**REFUSAL OF PLANNING PERMISSION**

**[Heldon And Laich]  
Planning Permission in Principle**

**Sub divide site for dwellinghouse and form new vehicle access at Stanes  
Cunningston Elgin Moray**

<b>Ref No:</b>	24/00428/PPP	<b>Officer:</b>	Shona Strachan
<b>Proposal Description/ Address</b>	Sub divide site for dwellinghouse and form new vehicle access at Stanes Cummingston Elgin Moray		
<b>Date:</b>	04/07/2024	<b>Typist Initials:</b>	DJP

DRAWING DESCRIPTION  
**Site Plan**

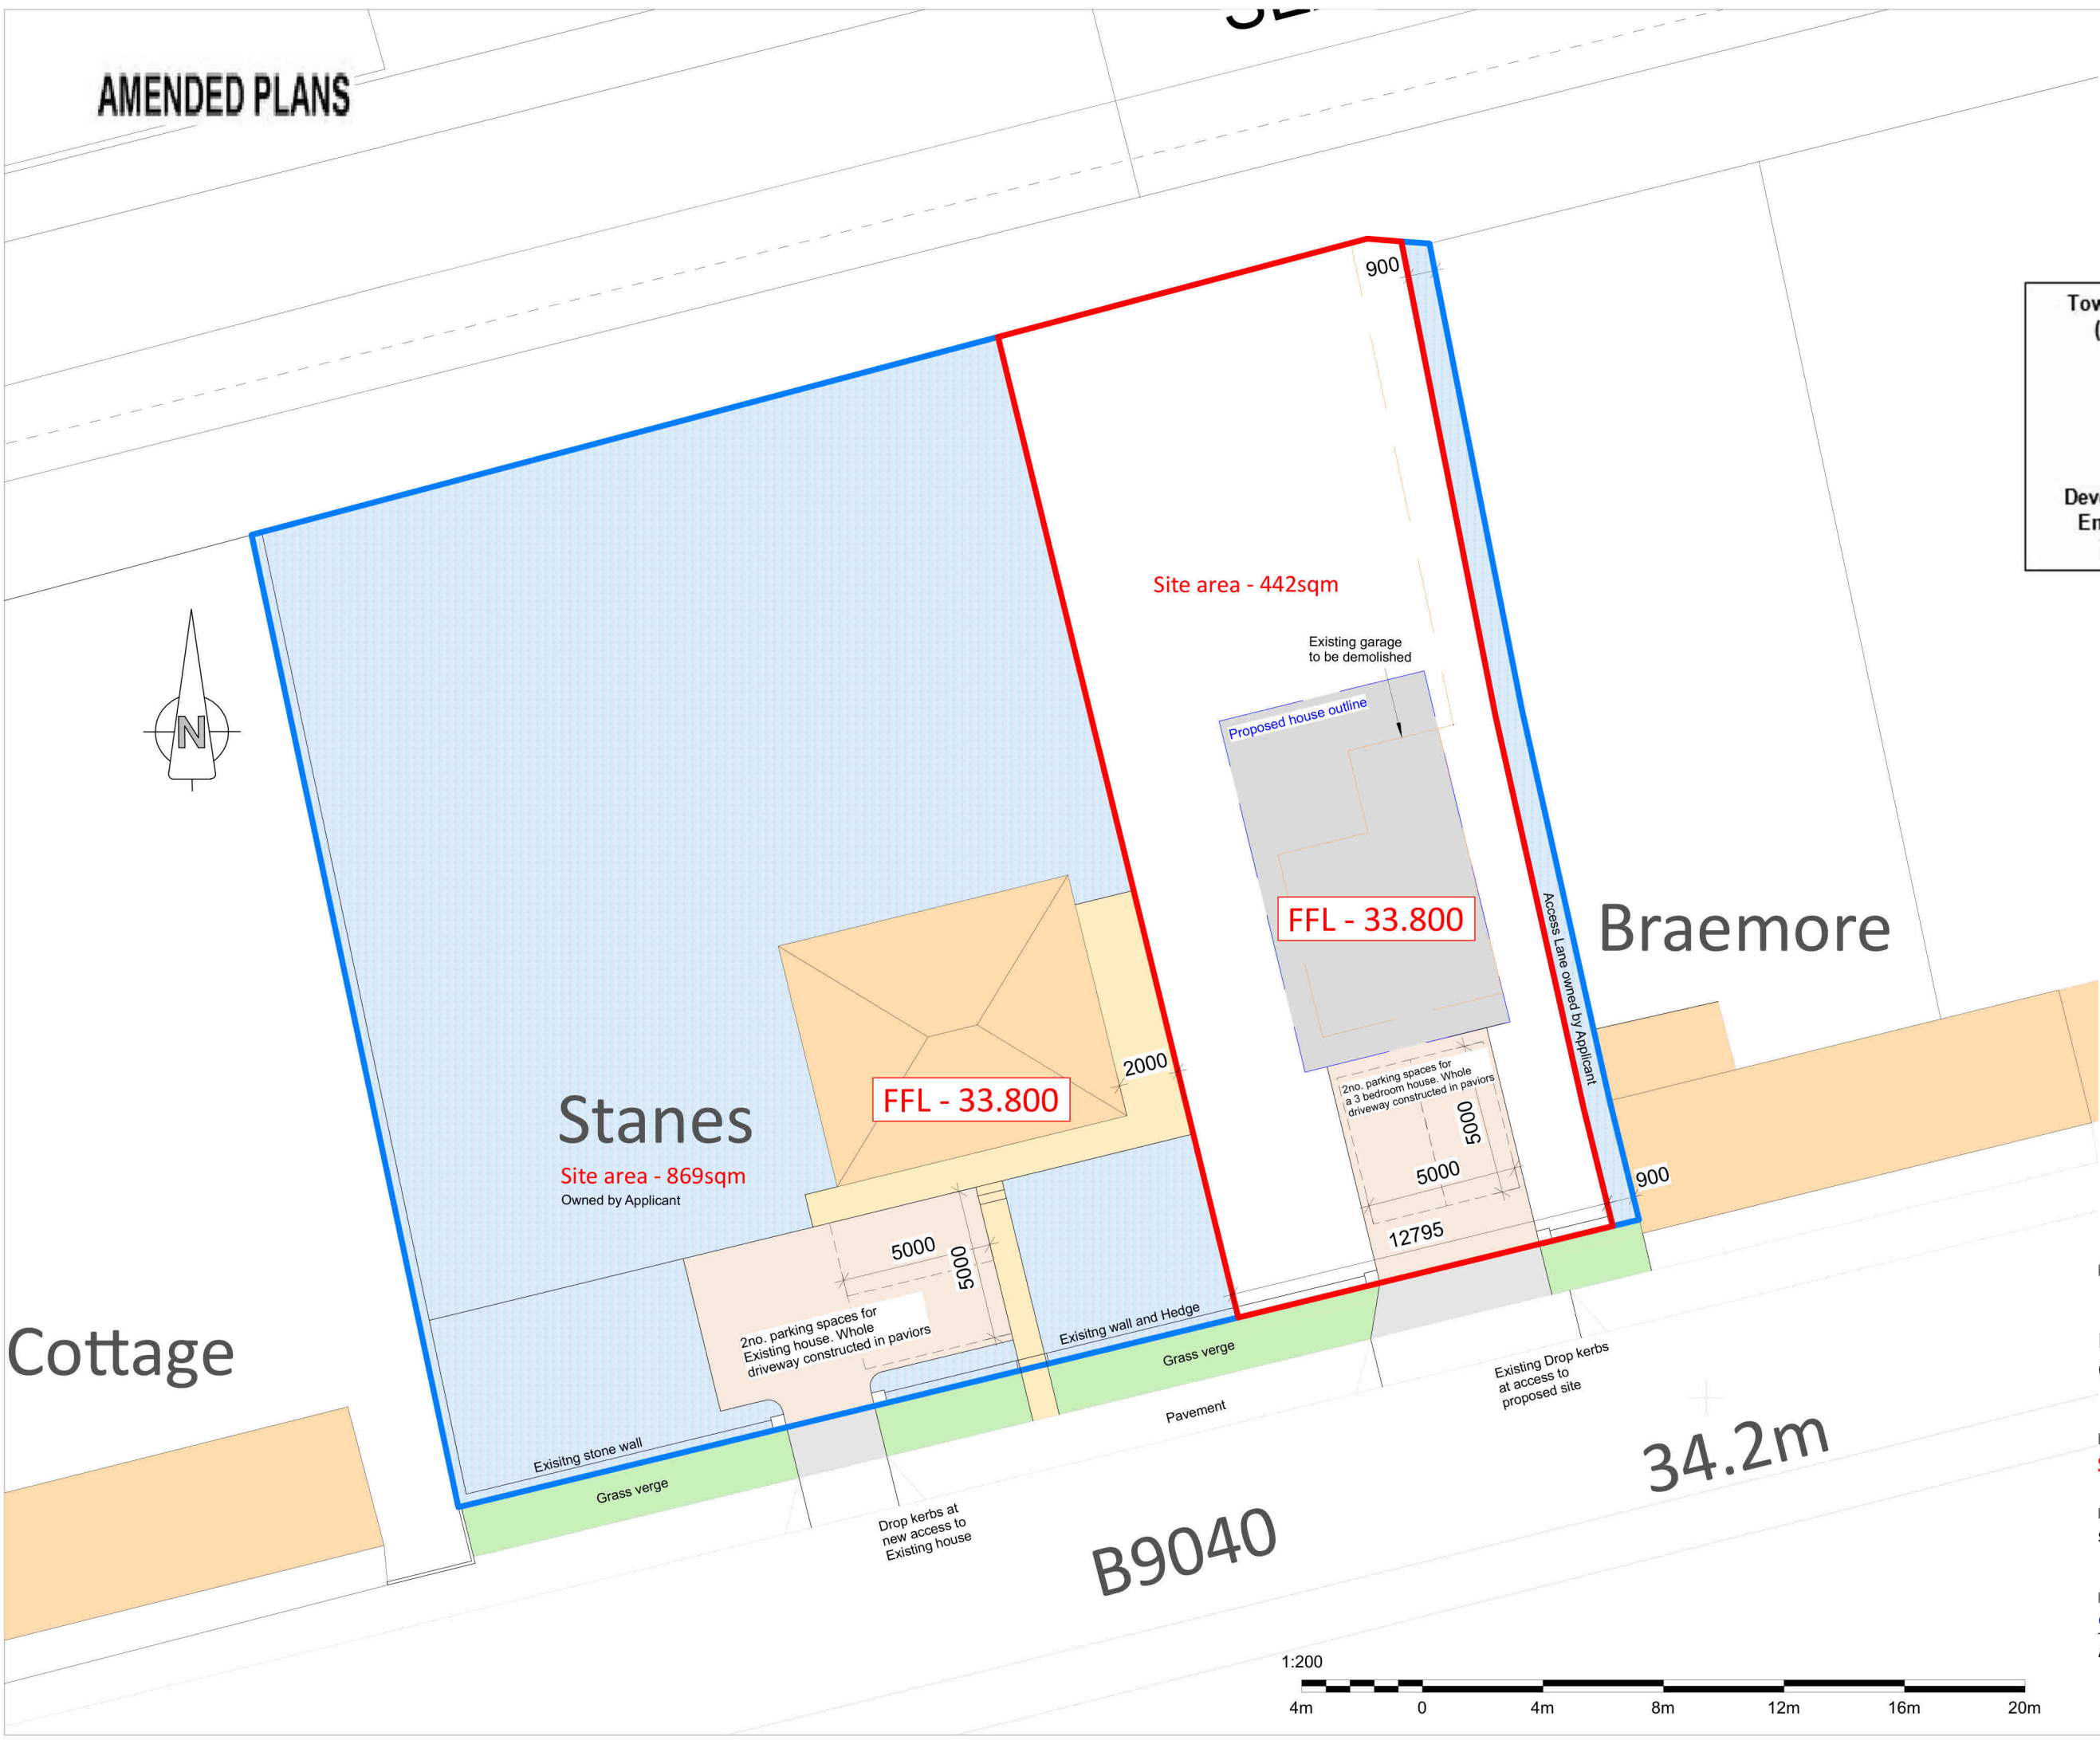
As this is an application for planning permission in principle detailed design information has not been provided. The site plan does show an indicative position and footprint for the proposed dwelling and also shows the site access, as well as a new access to be formed for the existing property. During the course of the application an amended site plan was submitted to show a reduced house footprint. This plan is indicative and forms the basis for this assessment.

As shown on the site plan, under this proposal the existing property would be sub divided to the east of the site and would entail the removal of the existing flat roofed garage with the proposed house to be positioned at this location. Beyond the site boundary to the east is a narrow access lane with the existing neighbouring property beyond, this eastward neighbouring property is a narrow spanned small proportioned cottage. The public road is to the south of the site which is lined with existing properties and the parent to the west. The garden ground of the property extents to the north and includes a change in level.

Having considered the proposal in detail and following discussion with the DM Manager, I can advised that should this case proceed to determination it will be refused as being determinantal to the character of the site. Given the presence of the existing traditional single storey property located centrally in the plot any development proposals to be sited on what is ancillary grounds to the existing property will appear cramped and incongruous to the existing layout.

Amended site plan submitted showing a reduced house footprint.

A Boundary amended

Our existing application shows a proposed footprint area that is actually much larger than what would be required for Mrs Noble's requirements so I have asked Chris to prepare a new site plan (attached) showing what would be a fairly standard sized 2 bedroom bungalow on it to be more representative of what would actually be formed on site should this proceed through outline planning. We have also positioned it further away from the exiting house whilst still leaving part of the lane for access purposes and a reasonable space to the side of the proposed new bungalow and increased 2m width to the side of the existing home, this will leave the proposed single storey house over 6m away from the existing bungalow so this should not in any way be deemed "cramped" especially in relation to the other properties highlighted above.
